HISTORIC AND DESIGN REVIEW COMMISSION

HDRC CASE NO: 2025-001
ADDRESS: 362 E HUISACHE AVE
LEGAL DESCRIPTION: NCB 3088 BLK 4 LOT 15
ZONING: R-4, H
CITY COUNCIL DIST.: 1
DISTRICT: Monte Vista Historic District
APPLICANT: Anthony Chen/Aeonium Investments LLC
OWNER: BEAM GREGORY & ALISON
TYPE OF WORK: Final Approval - Garage/ADU
APPLICATION RECEIVED: December 30, 2024
60-DAY REVIEW: February 28, 2025
CASE MANAGER: Bryan Morales
REQUEST:

The applicant is requesting approval to construct an approximately 360 sf detached rear accessory structure.

LEFT ELEVATION
SCALE: 1/4" = 1'

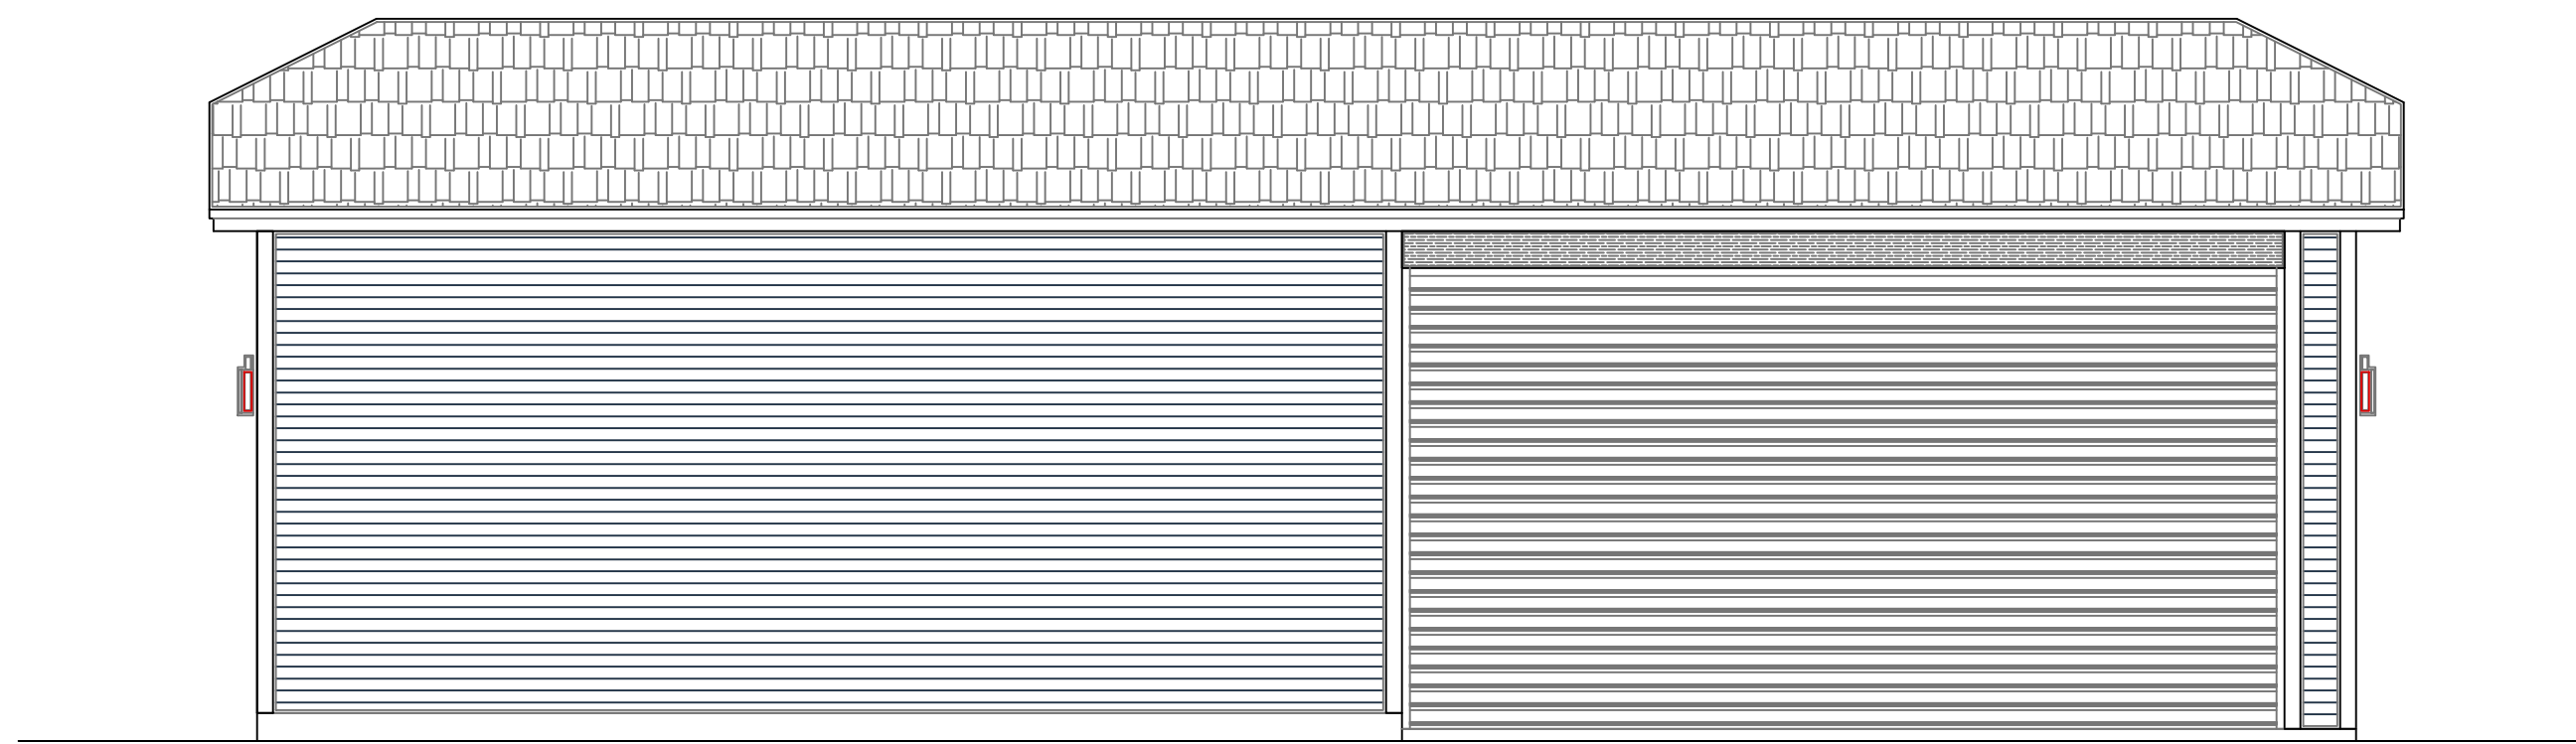
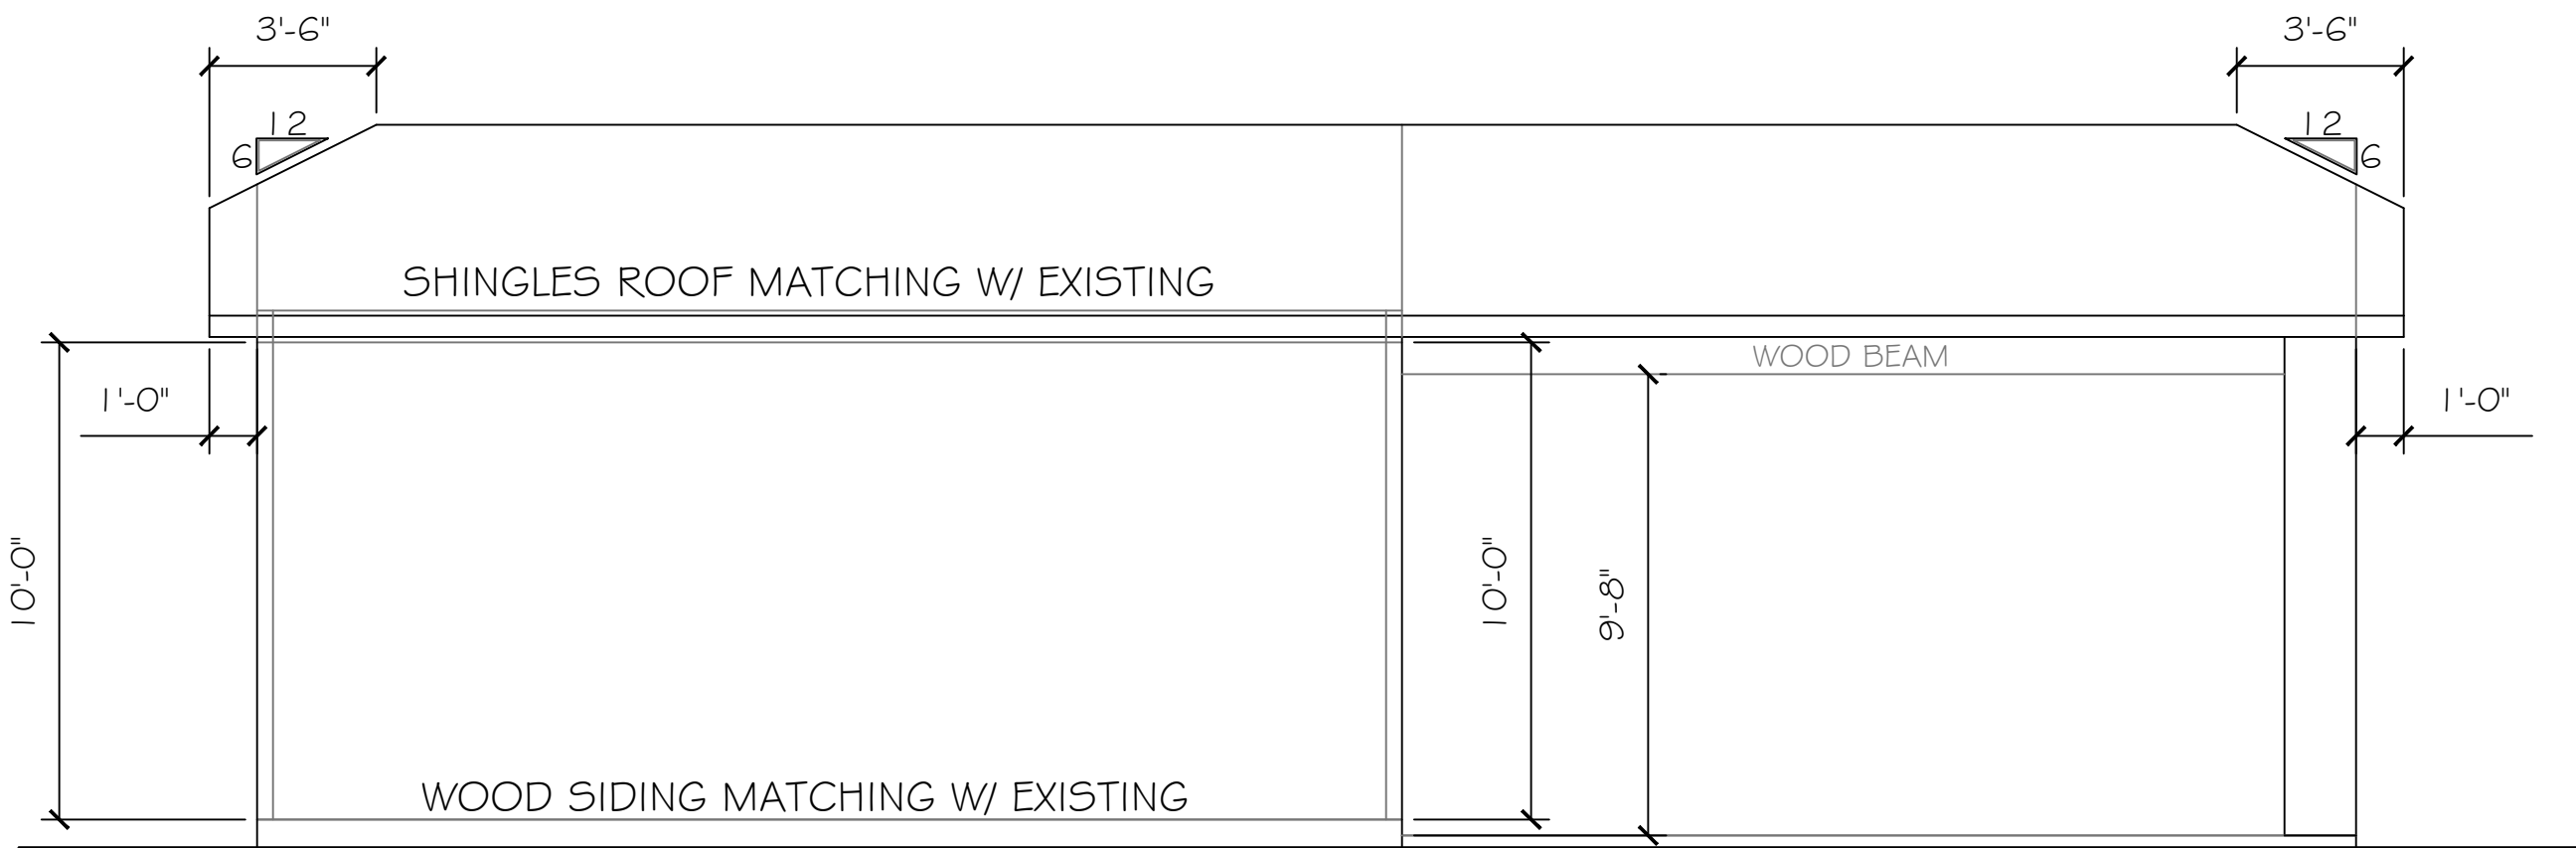
- e. ARCHITECTURAL DETAILS – The applicant is requesting approval to construct a 1-story accessory structure at the rear of the property featuring a roof vent, Craftsman roof brackets, and louvered wood wall sections. The Guidelines for New Construction 5.A.iii. and 5.A.iv. note that new accessory structures should relate to the period of construction of the primary historic structure on the lot by using complementary materials and simplified architectural details. Staff finds the roof vent, roof brackets, and louvered wood wall sections generally appropriate.

- f. ARCHITECTURAL DETAILS (MATERIALS) – The applicant is requesting approval to construct a 1-story accessory structure at the rear of the property with a composition shingle roof and 117 wood siding. The Guidelines for New Construction 5.A.iii. and 5.A.iv. note that new accessory structures should relate to the period of construction of the primary historic structure on the lot by using complementary materials and simplified architectural details. Staff finds the proposed composition shingle roof generally conforms to Guidelines. Staff finds the installation of 117 wood siding generally conforms to Guidelines. New Construction 2.B.i states that roof

forms—pitch, overhangs, and orientation—consistent with those predominately found on the block should be incorporated. Staff finds the proposed hip-on-gable roof and its pitch conforms to Guidelines.

- g. ARCHITECTURAL DETAILS (FENESTRATION PATTERN) – The applicant is proposing to install one Craftsman wood door on the right façade, one garage door on the front façade, and three rectangular windows on the right façade. The Guidelines for New Construction 2.C.i. related to window and door openings stipulates to incorporate window and door openings with a similar proportion of wall to window space as typical with nearby historic facades. Staff finds the proposed fenestration pattern generally appropriate. The applicant has noted they will match the rectangular windows located on the historic primary structure.

- i. That the applicant meets all setback standards as required by city zoning and obtain a variance from the Board of Adjustment if applicable.
